**MINUTES**  
**INFRASTRUCTURE REVIEW ADVISORY BOARD**  
**OAK VIEW LIBRARY**  
**December 9, 2015 8:30 a.m.**

**b. Proposed Revisions to Sanitary Sewer Supplemental Specifications (Section 100), Engineering Design Standards (Chapter 9) and Standard Plates**

**Date:** December 9, 2015  
**To:** Infrastructure Review and Advisory Board  
**From:** Public Works – Engineering  
**Subject:** Proposed Specification Updates

PLATE  
NUMBER  
950.05

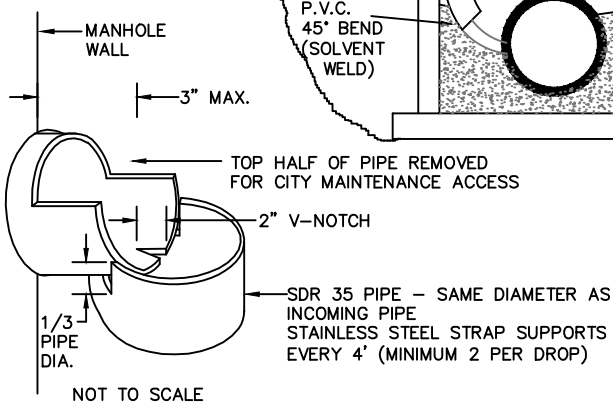
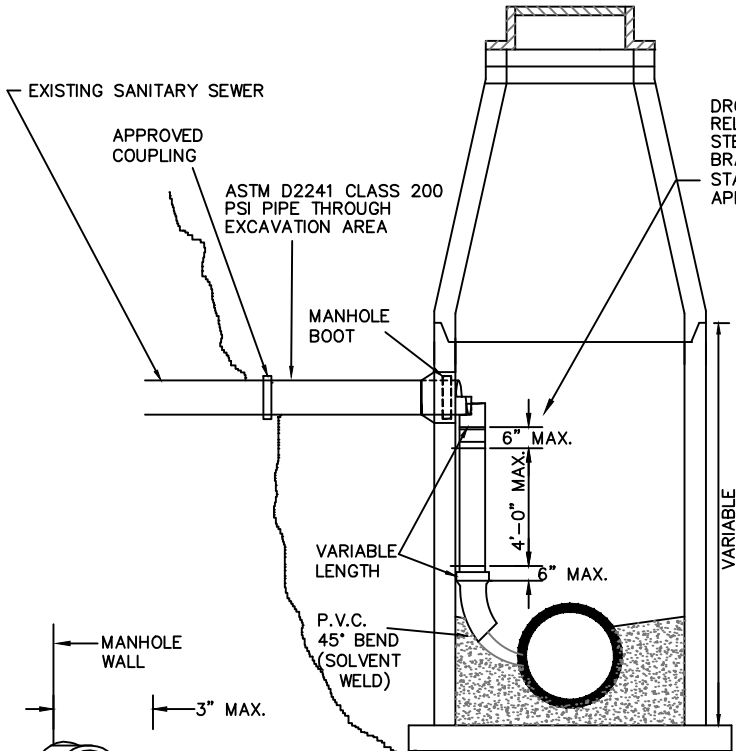
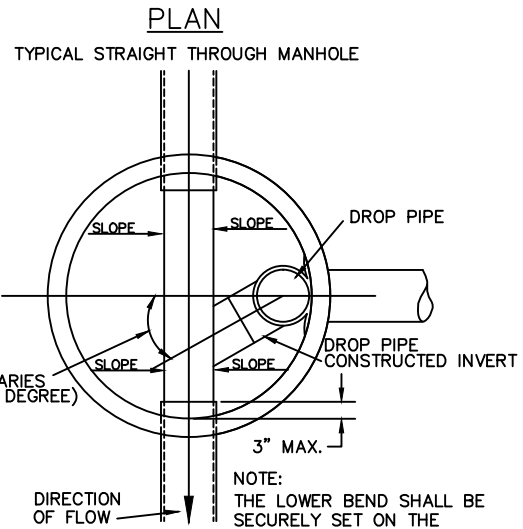
Plate 950.05 Sanitary Sewer Manhole Bowl Type Drop Section – See attached memorandum.

**THE DIAMETER OF THE DROP PIPE SHALL BE THE SAME DIAMETER AS THE INCOMING PIPE.**

PLATE  
NUMBER  
950.06

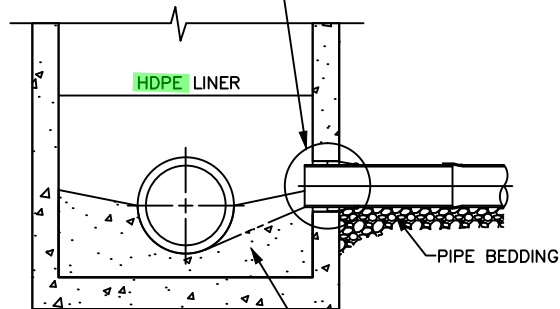
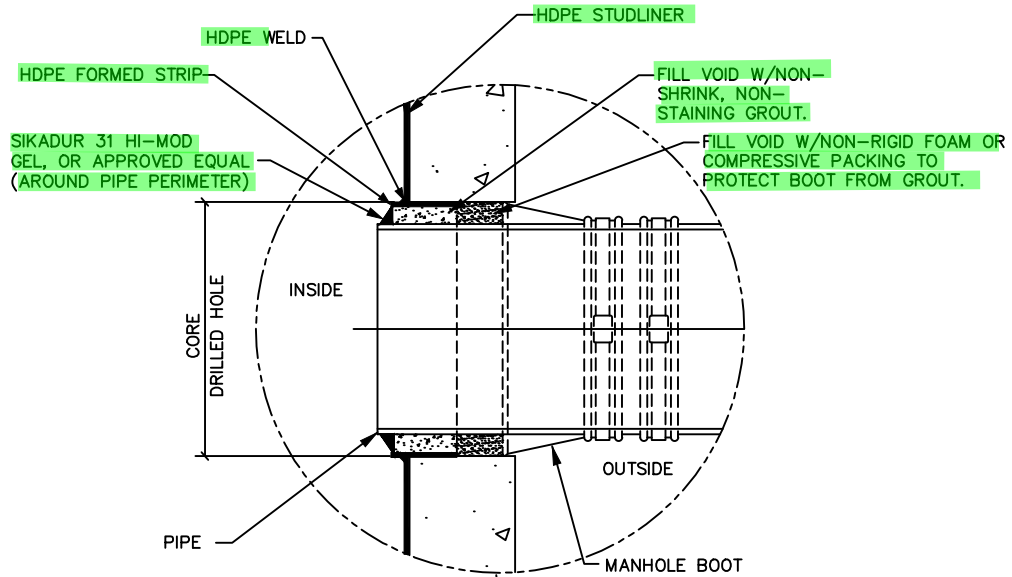
950.06 Sanitary Sewer Manhole Drop Section for 12" Pipe and Larger – See attached memorandum.

THE DROP SECTION SHALL BE USED ONLY WHERE MATERIAL SIZES ARE NOT AVAILABLE FROM THE MANUFACTURER FOR THE BOWL TYPE DROP SECTION.

HOLES DRILLED THROUGH THE LINER TO FASTEN BRACKETS SHALL BE SEALED WITH SIKADUR 31 HI-MOD GEL OR APPROVED EQUAL.
